## STAFF REPORT

### CITY OF COLUMBUS PLAN COMMISSION (April 8, 2026 Meeting)

**Docket No. / Project Title:** SUB-26-19 (Columbus Gateway Major Subdivision Preliminary Plat Revision)

**RE:    *Columbus Gateway Major Subdivision Preliminary Plat Revision  
(Plan Commission Case #SUB-26-19)***

C0.0

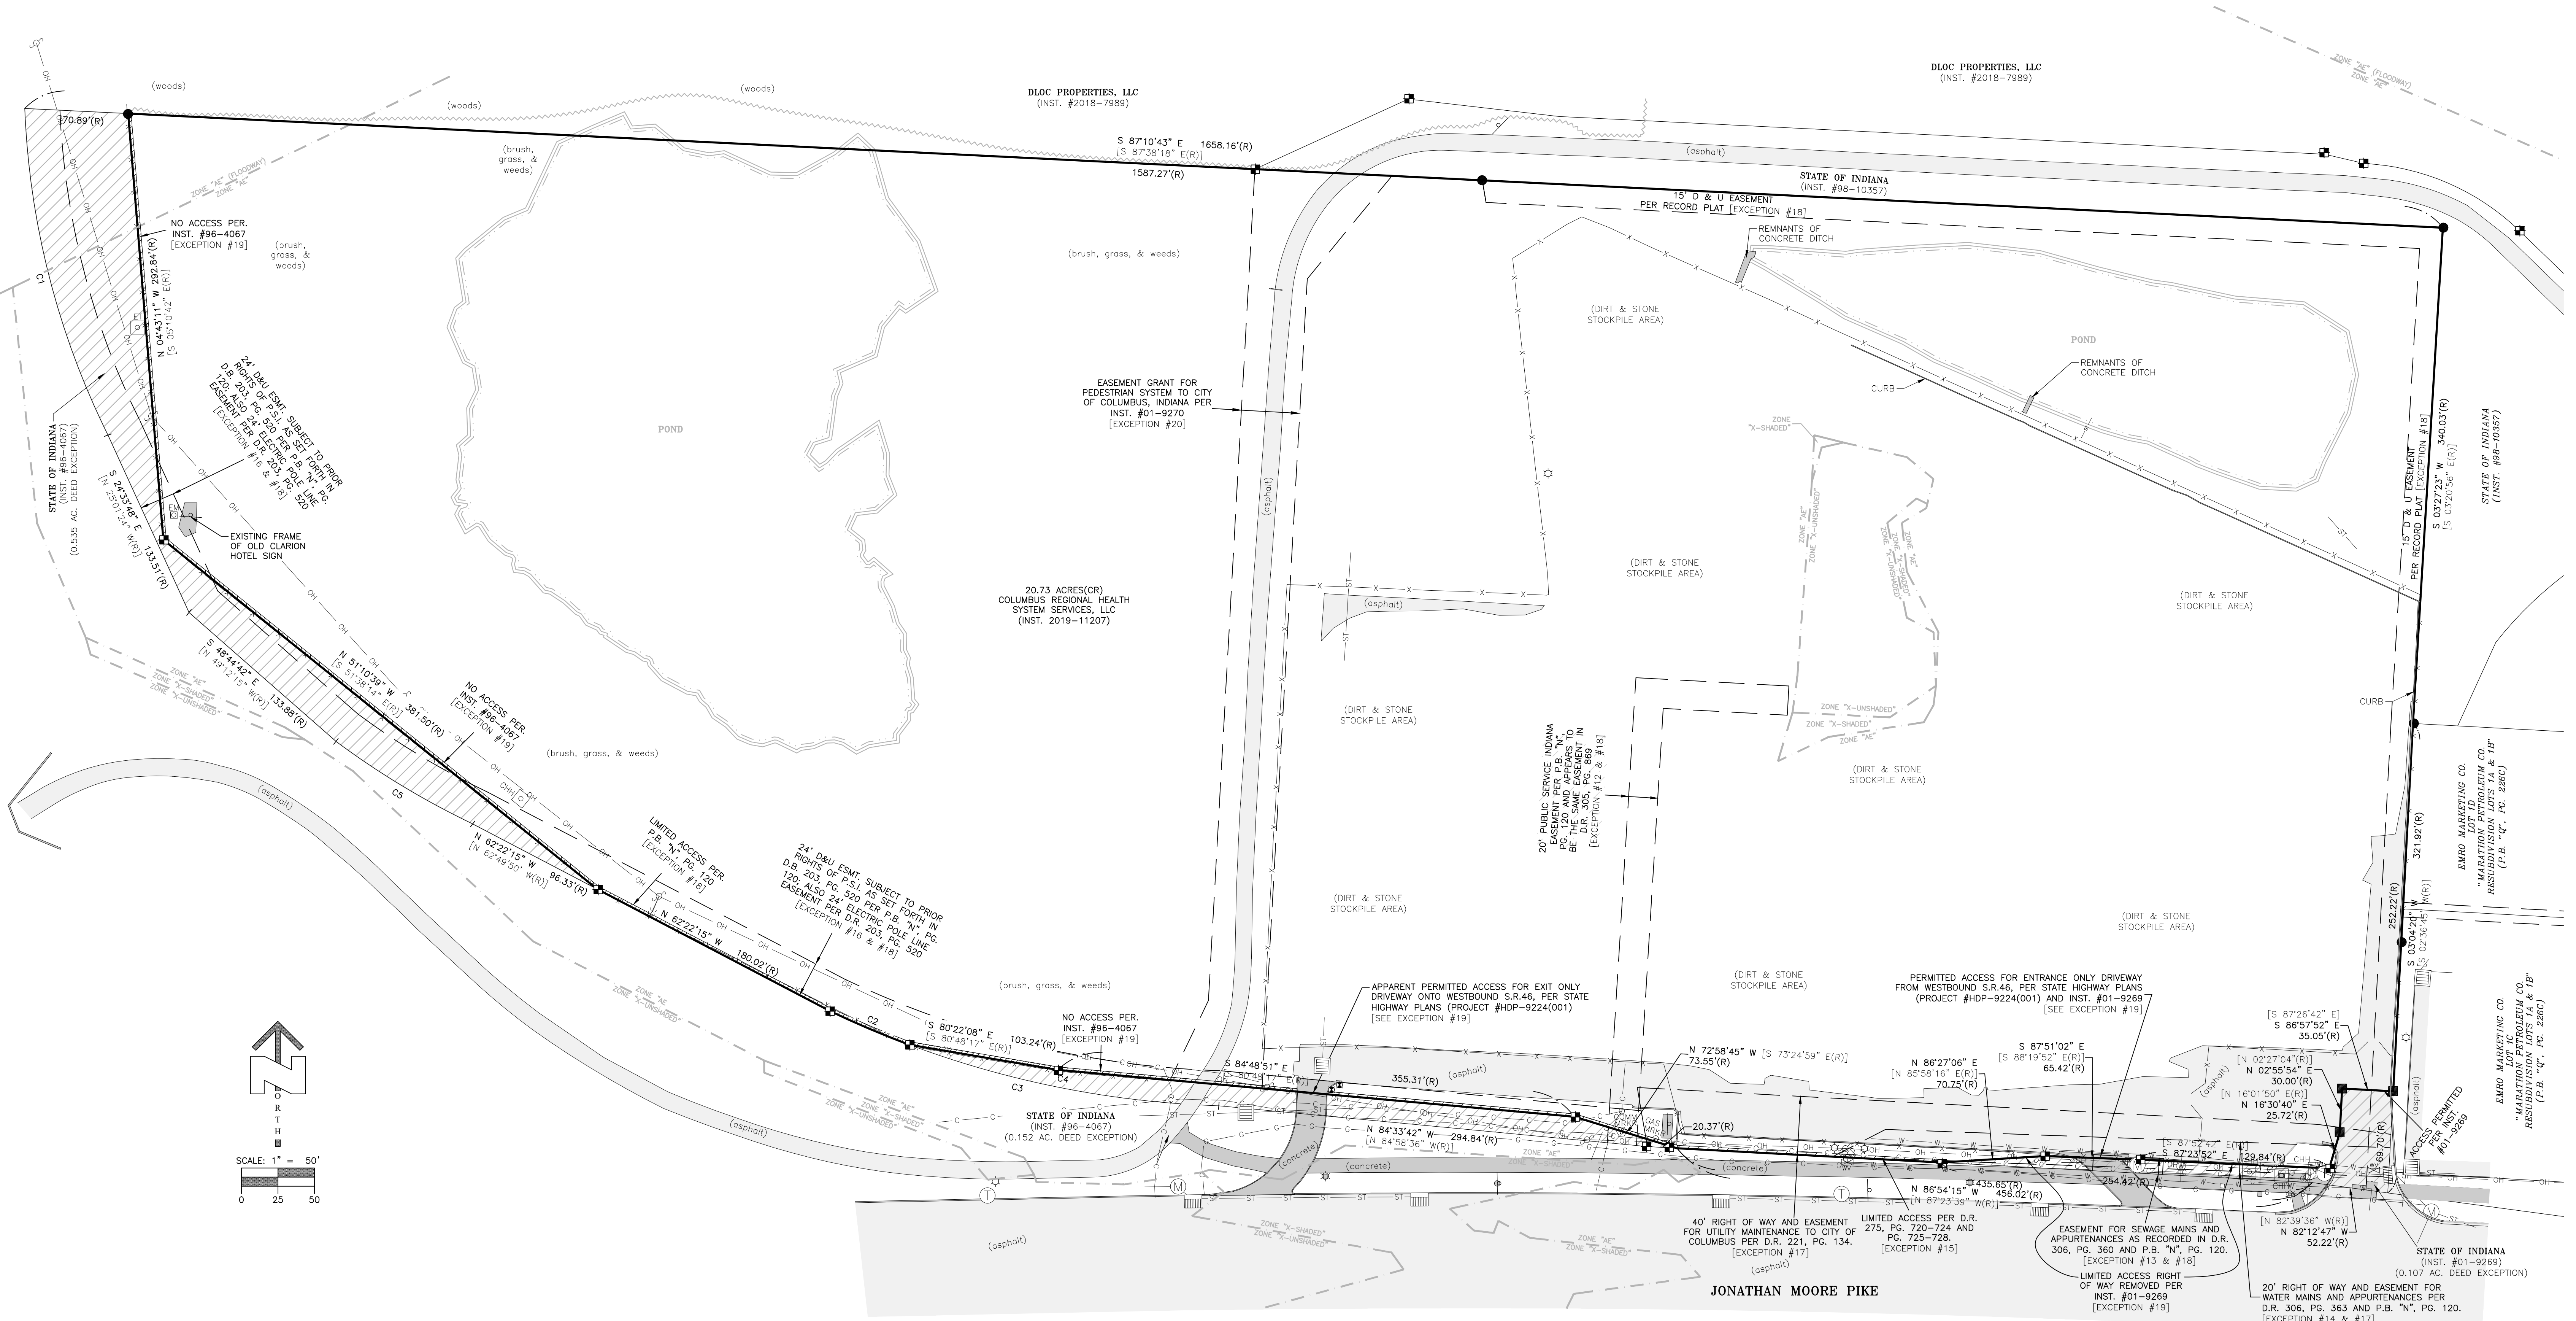
- b. In the title block, the name of the project shall be revised to “Columbus Gateway Major Subdivision Preliminary Plat Revision”. This will be required on all sheets.

- a. Rename “Columbus Gateway Major Subdivision Preliminary Plat Revision”.

- b. In the Agency Contacts table, remove "...Economic Development" from the Planning Department contact line.

- Owner name and parcel info missing

***Response: The Cover Sheet and titleblock have been revised to indicate the specified language.***

***Response: The Cover Sheet and titleblock have been revised to indicate the specified language.***

***Response: The Agency Contacts table has been revised as requested.***

***Response: Updated subject parcel ownership information has been added to the Cover Sheet, underneath the contact information tables.***

**C1.0**

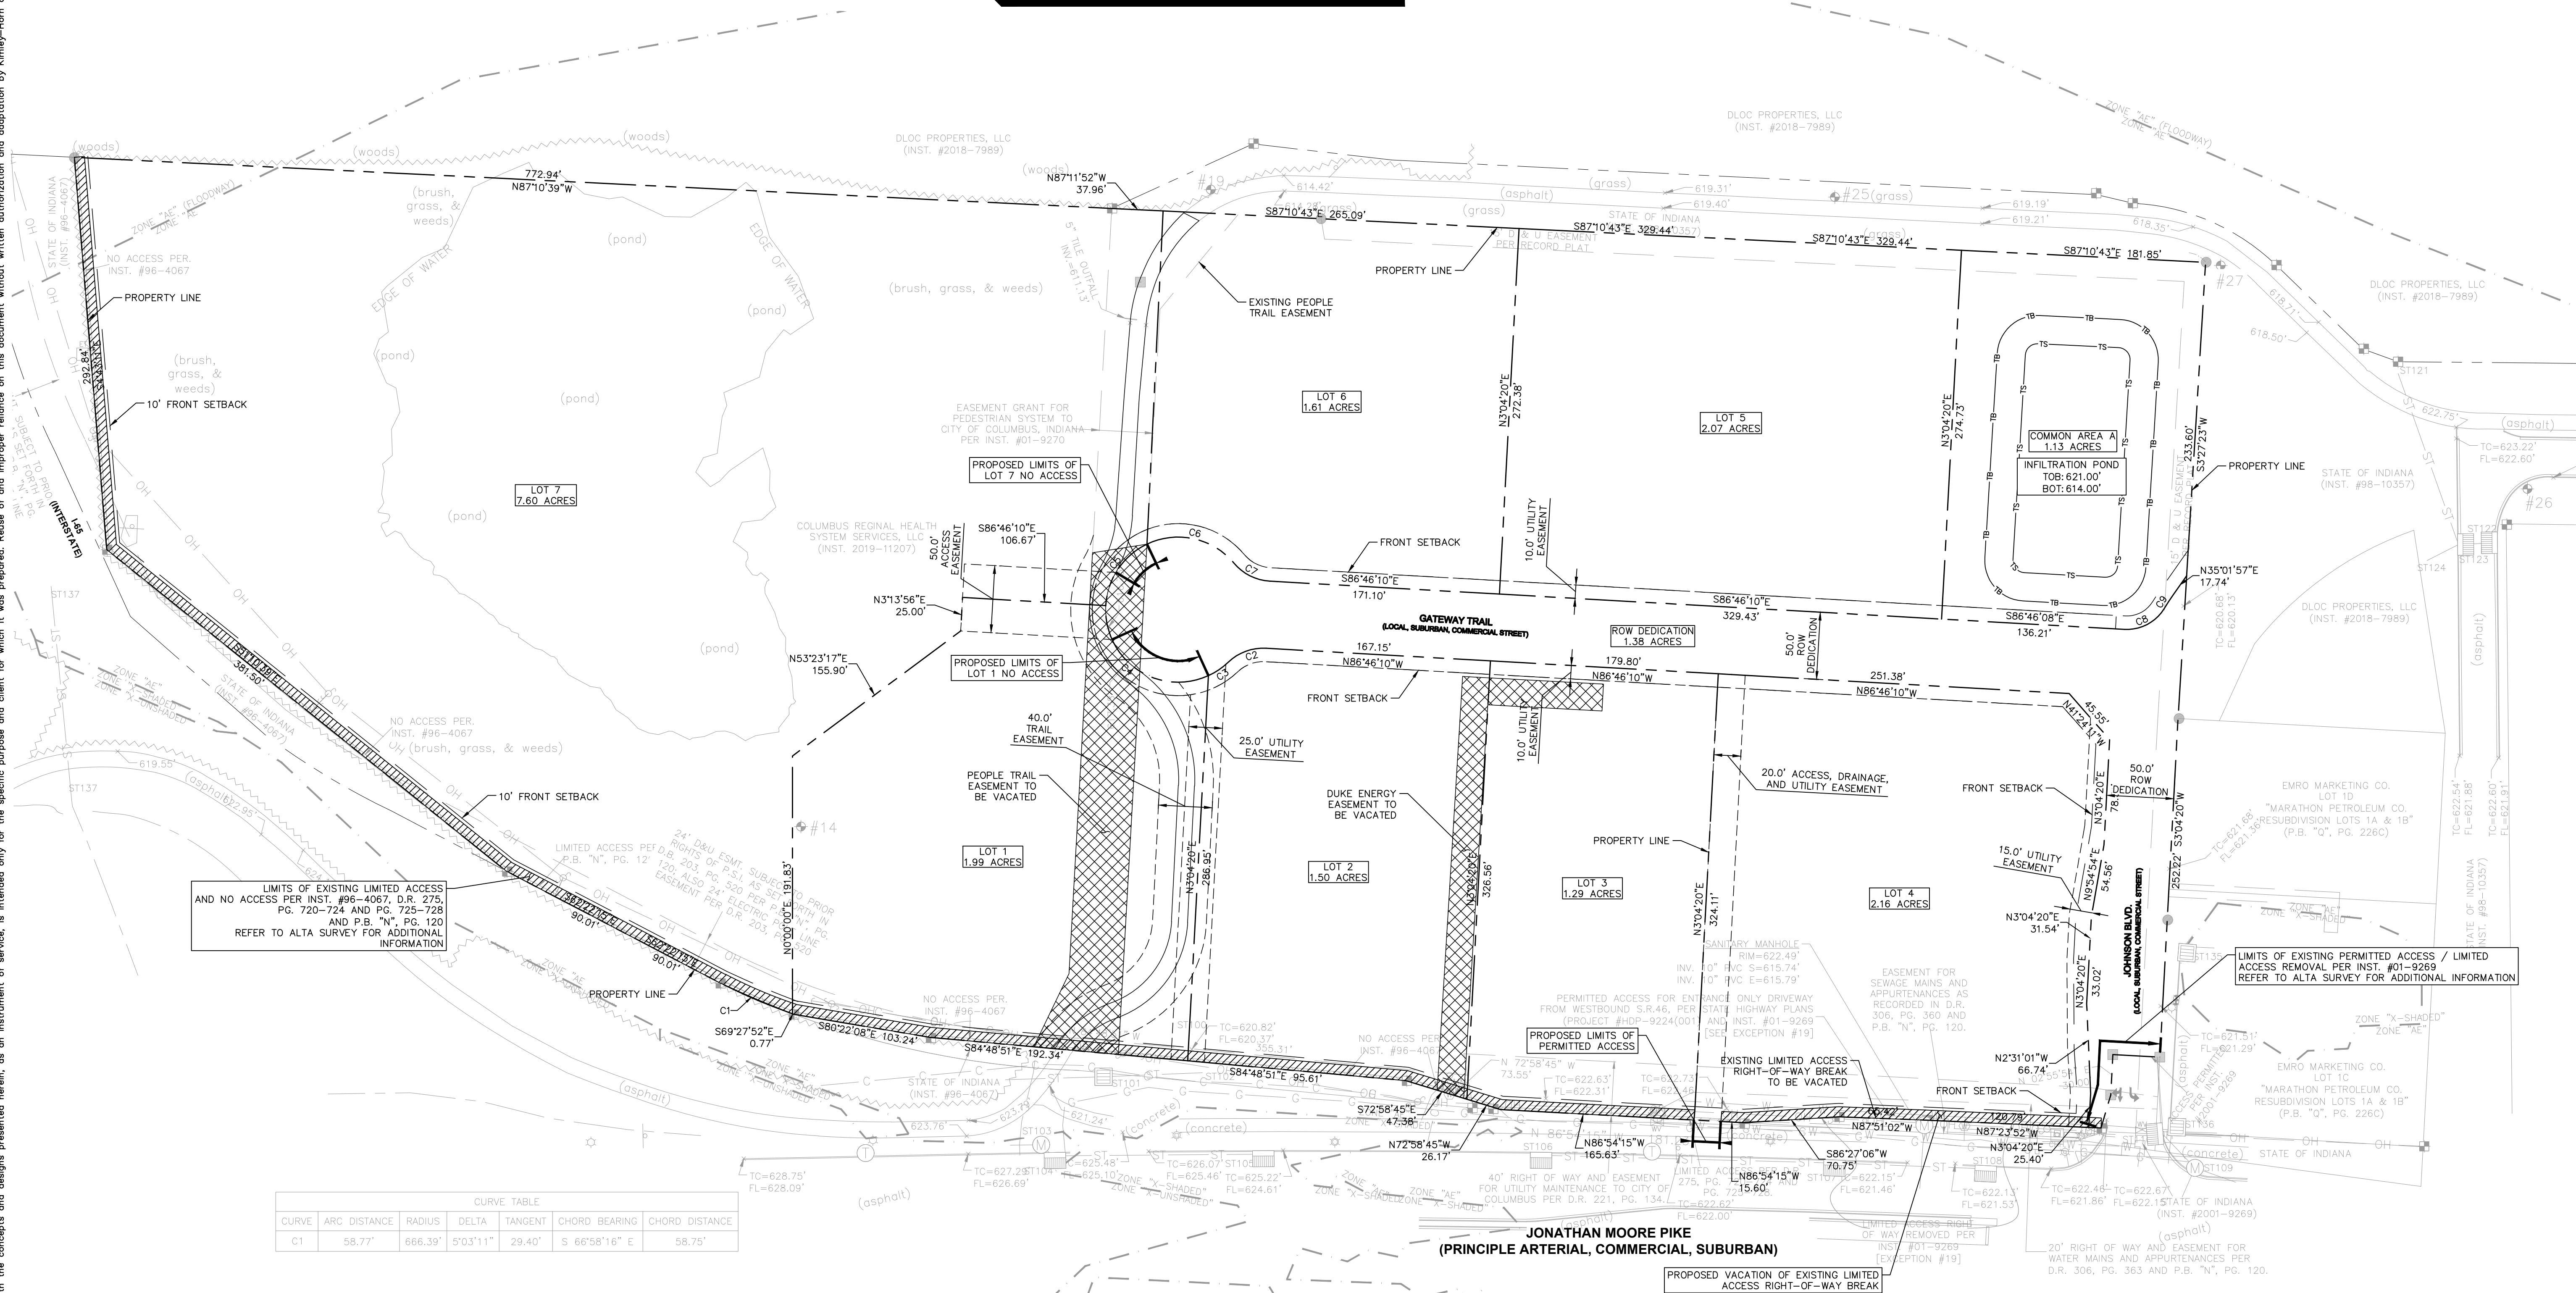
1. Sheet C1.0 – Preliminary Plat:
  - a. The word “proposed” shall be omitted from the notes referencing Lot 1 and Lot 7’s limited access areas.
  - b. The access easement shall be relabeled as an “access easement and reserved right-of-way”.

- c. The property boundary for Lot 1 should be moved to be adjacent to the access easement on Lot 7. In other words, the easement and reserved right-of-way should be completely located on Lot 7, and not on Lot 1.

- a. Revise the property line notation between Lot 3 and Lot 4 to clearly indicate where the adjusted property line is located.

- b. Revise the drawing to depict Gateway Trail cul-de-sac and access easement as we spoke about in the SRC meeting. This easement should note that it is intended to serve.

***Response: The specified property line label has been adjusted as requested.***

***Response: Limits of "no access" along Lot 1 and Lot 7 frontage have been explicitly identified on Sheet C1.0 as requested at SRC meeting.***
